# UNITED STATES PATENT AND TRADEMARK OFFICE

| APPLICATION NO. | FILING DATE | FIRST NAMED INVENTOR | ATTORNEY DOCKET NO. | CONFIRMATION NO. |
|-----------------|-------------|----------------------|---------------------|------------------|
| 09/826,070      | 04/04/2001  | Jeffrey D. Messerly  | END-0736            | 4524             |

**Office Action Summary**

For claim 21 and claim 22

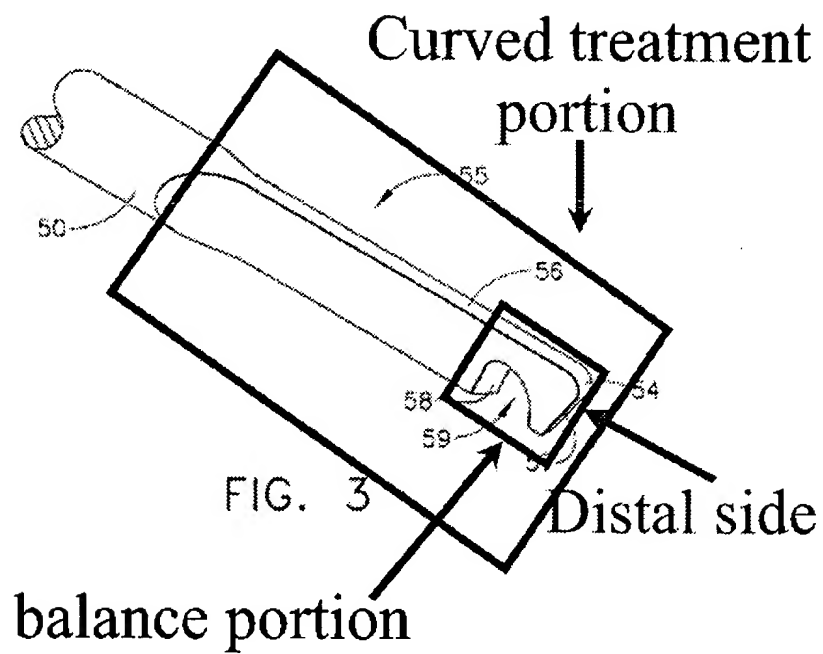
4. Claim 21-24 and 26 are rejected under 35 U.S.C. 102(e) as being anticipated by Huitema US 6117152.
5. Regarding 21-23, as best understood, Huitema discloses a waveguide 50 comprising a blade 56 a distal portion (right side of the notch 59) and a proximal portion left side of the notch, a curved treatment portion right portion of the figure (see first attached diagram). A balance portion is labeled. The notch provides the asymmetry. Claims 21 and 23 are rejected under different interpretations of figure 3. The first attached figure is relevant to claims 21 and 22, while the second attached figure is relevant to claim 23.

6. Regarding claims 22, the balance portion extends from the distal tip of the blade to a point inside the treatment portion.
7. Regarding claim 23, though it is not clear how the balance portion and treatment portion are connected, as best understood, the Huitema reference discloses this feature. The second attached diagram shows the new relationship between the balance portion and the treatment portion.
